# **Report to Committee**

RZ 07-380219

Application by Toyu Group Holdings Ltd. for Rezoning at 7751,

7851 Bridge Street and 9531, 9551 Blundell Road from Single-Family Housing District, Subdivision Area F (R1/F) to Comprehensive Development District

Attachment 4: Preliminary Architectural Drawings

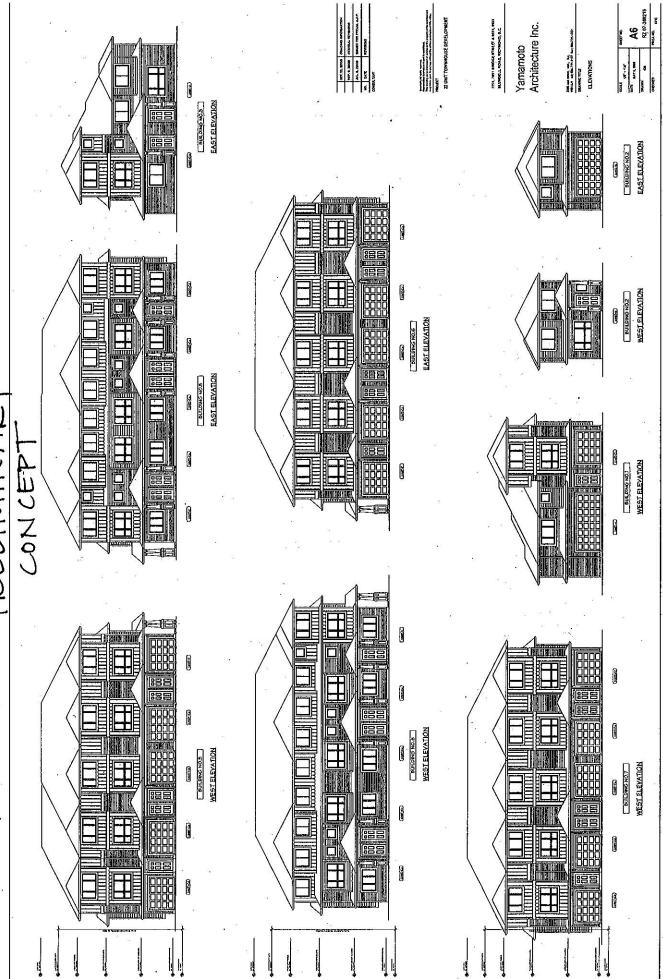
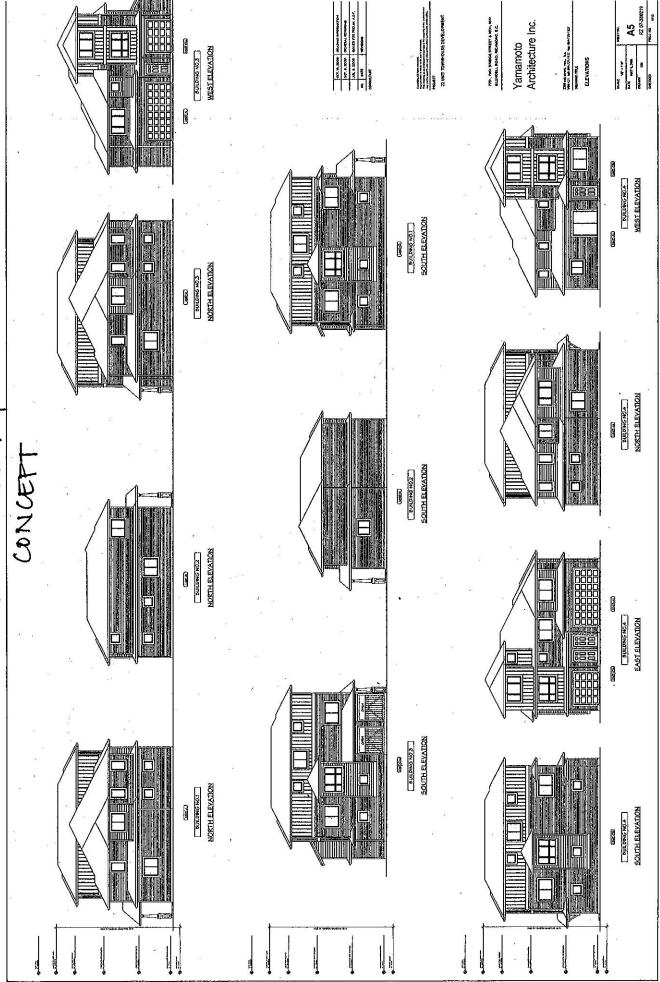
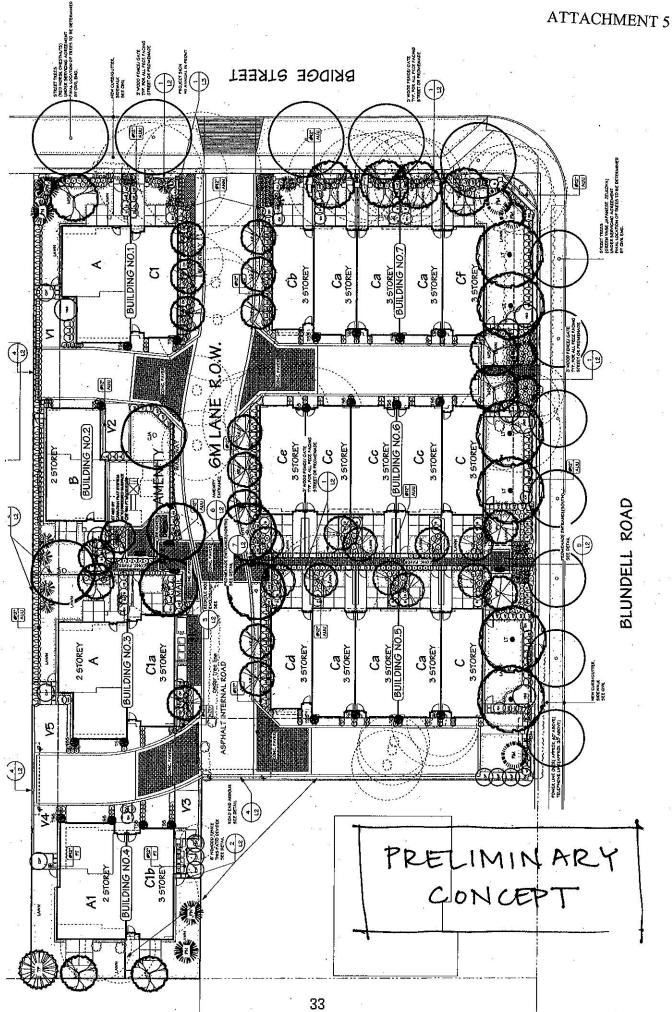
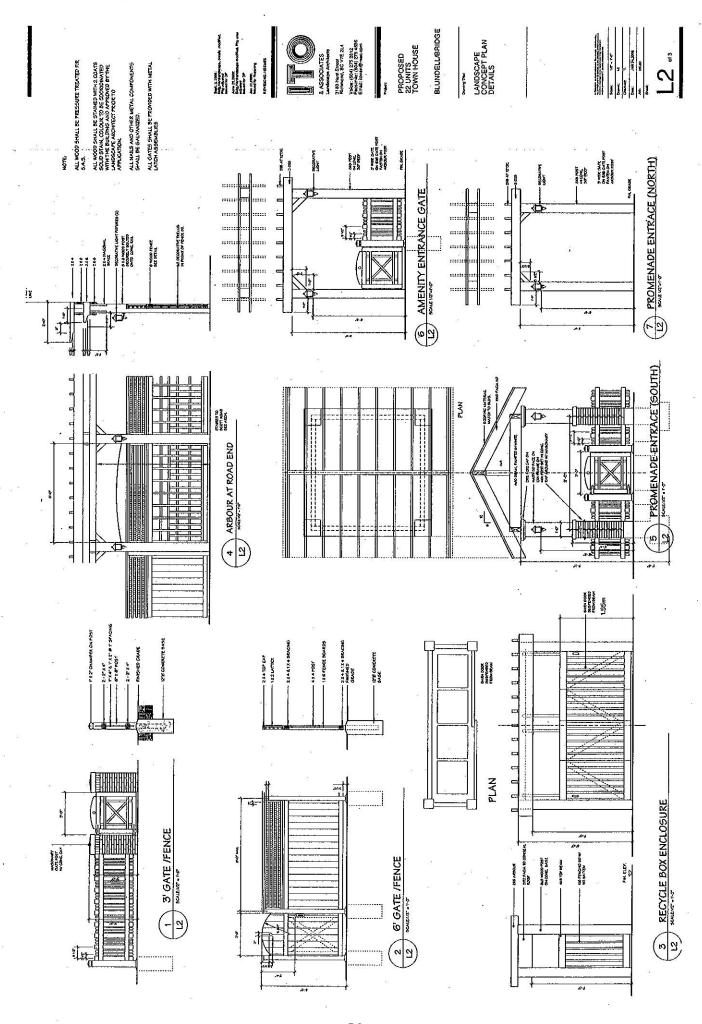
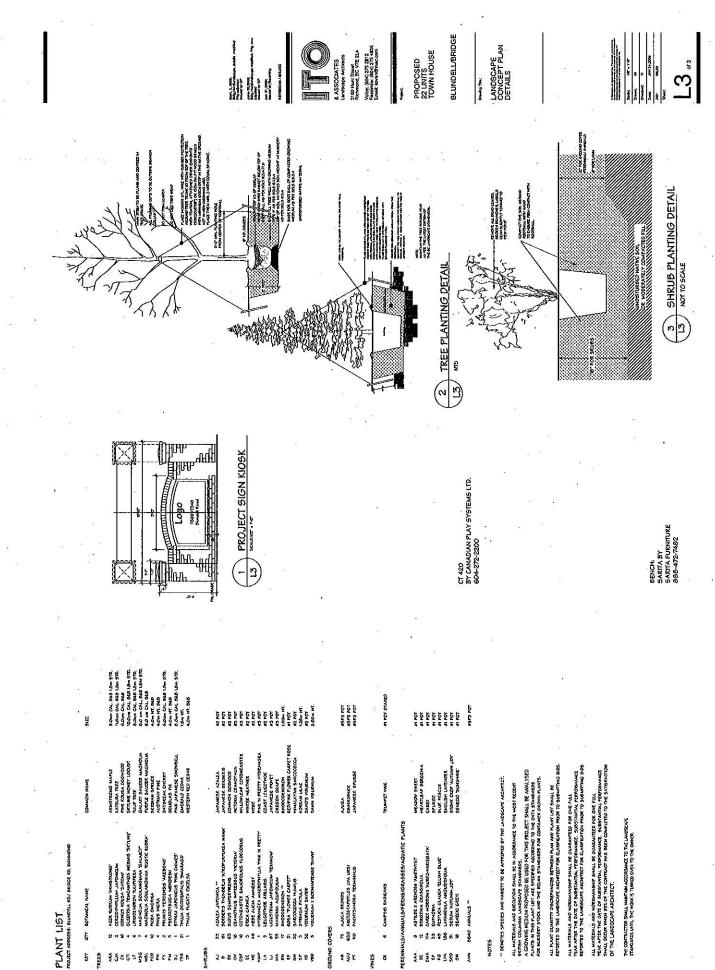
- two-storey unit A could be easily converted into an adaptable unit;
- try to locate accessible visitor parking close to the adaptable unit;
- consider increasing diversity in plant species to be used in landscaping (ex. Magnolias);

- pedestrian safety needs to be addressed in view of the public lane;
- differentiation is needed between public and private space;
- The typology seems to want to be row-housing instead of a larger mansion and back lane carriage housing. Try to reinforce the unit identities as individualized and separate;

- difficult project to conquer. The general form and arrangement of blocks is appropriate. The
  lane is a challenge. Concerned about children running to amenity area across lane. Lane
  needs traffic calming. Either step down massing south of amenity area or move it for
  sunlight penetration;

- 'prairie style' is not convincing because of the building height and lack of overhangs; the building should be broken down into manageable pieces. Look at English rowhouses;

- entrances to buildings are too small considering the size of the buildings;
- buildings 1 and 2 on the north side can be rotated at 90 degrees so that a series of private drive aisles and building and garage entrances will be bisected by the public lane to preclude interference between the lane and unit entries;

- public and private roads can be differentiated through the paving materials used;
- landscaping along the public lane may not be advisable as it would obstruct both the motorists' view of pedestrians and access to drive-ways;

- use of lighting provided on the buildings is recommended over cobra head lane light standards, provided the lighting is wired to the house circuit to be turned on all the time;

- the "tower" element that appears in two units may be more appropriate at the corner;
- brick entry from Bridge Street may not serve any purpose, does not mark private entry and can be dispensed with;

- reconsider the Blundell pedestrian entry. Nice structure, but location seems arbitrary;
- streetscape yards and frontage are good. Materials and colours to bring variety; and

- a pedestrian mews connected to Blundell instead of back yards would be more appealing.

- he does not have the same level of concern about the units fronting a public lane. Recesses and well-defined entries to the units would be necessary for pedestrian safety. There is no pedestrian access except through the public lane.
- narrowing the lane or placing bulges on both ends of the lane could be considered to slow down traffic. Or the lane could be stopped mid-block to stop through-traffic.

- turning the north units to extend the drive aisles across the lane would solve the lane interface issue, but would also likely result in a loss of units. Consider reducing the North setback to 1.2 m, reducing the Blundell setback, or shifting the lane to regain some units.
- the security of the lane could be addressed with a private look, making it inconvenient for non-residents.

- 1. consider providing the opportunity of converting unit A into an accessible unit *Incorporated in buildings 1 & 3*;
- 2. ensure that handicapped parking is near the adaptable unit Incorporated. Accessible parking space is located near building 3;
- 3. consider increasing the species diversity of the landscaping Will incorporate through the Development Permit design;
- 4. consider pedestrian circulation on the public lane Incorporated. Walkway provided north of the lane;
- 5. consider an alternative to the public lane for access to units along the north side Resolved.

Building orientation changed as suggested, resolving interface issue;
- 6. consider providing some separation between the public and private grounds in the lane area Resolved. Building orientation changed, resolving interface issue;

- 7. consider defining the units, especially those fronting the public lane area, as having a "coach house" style rather than a "large house" style Resolved. Building orientation and typology changed, so that no units are fronting the lane;

- 8. consider lower massing at 2-storey volume near the amenity space *Incorporated*;
- 9. consider providing some site signage and identity for the front entry *Incorporated*;

- 10. consider breaking down the massing into lower divisions to achieve a more "row-house" pattern *Incorporated*;
- 11. consider the observation that the "tower" element that appears in 2 units to be more appropriate on a corner —Two and three storey duplexes along north of site prove a transition from lower single-family homes and taller townhouses;

- 12. consider extending the format of the south side of the site to the north *Incorporated*; and
- 13. consider that the pedestrian entry structure from Blundell Road to drive aisle may not be valuable Entry structure aligns with pedestrian walkway and entries for buildings 5 & 6.
